Submission for Job: #6011 SSD 6011 - Mixed use residential development within the South West Plot

Site: #2825 SICEEP Site, The Haymarket; Darling Drive, Sydney

29 July 2013

LEVEL 6

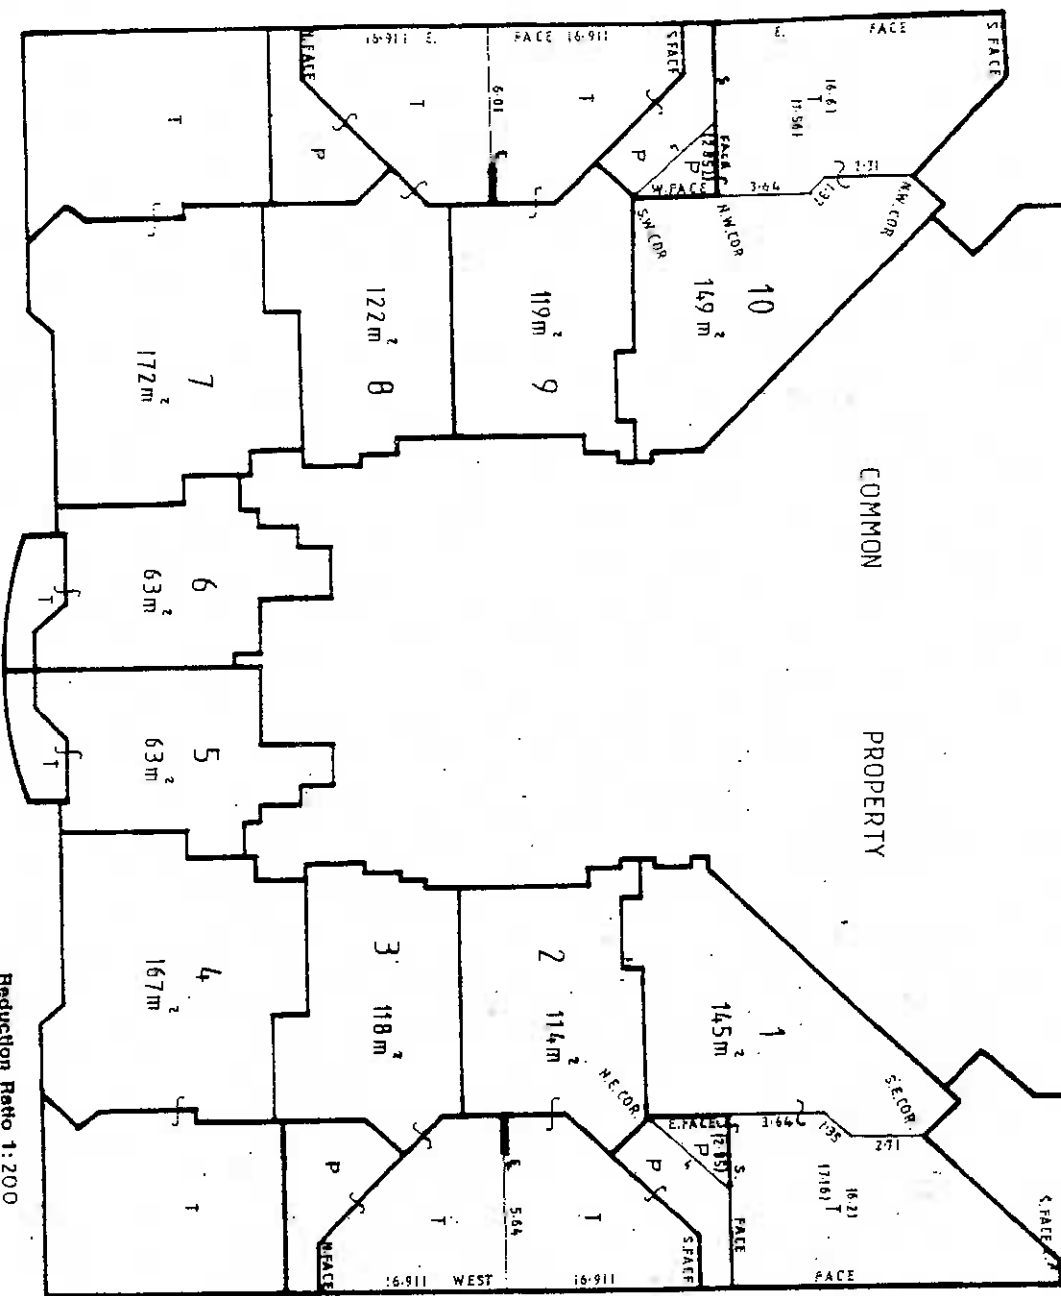
Levels 6 and 7 each contain two apartments with single west aspect , i.e. 4 single aspect apartments.

LEVEL 8

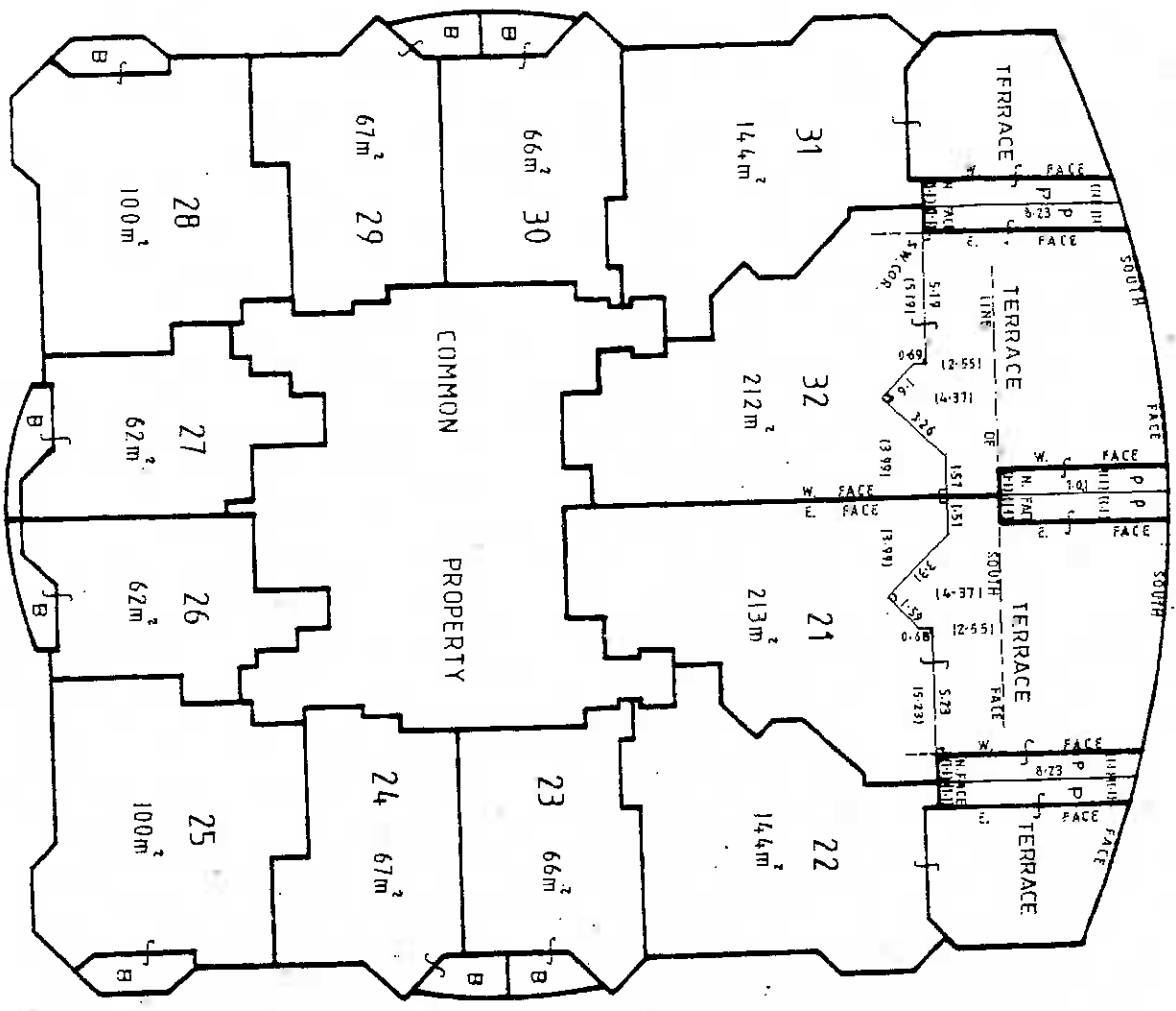
Levels 8-15 each contain two apartments with single west aspect and two apartments with single north aspect , i.e. 4 single aspect apartments per level, giving 32 single aspect apartments.
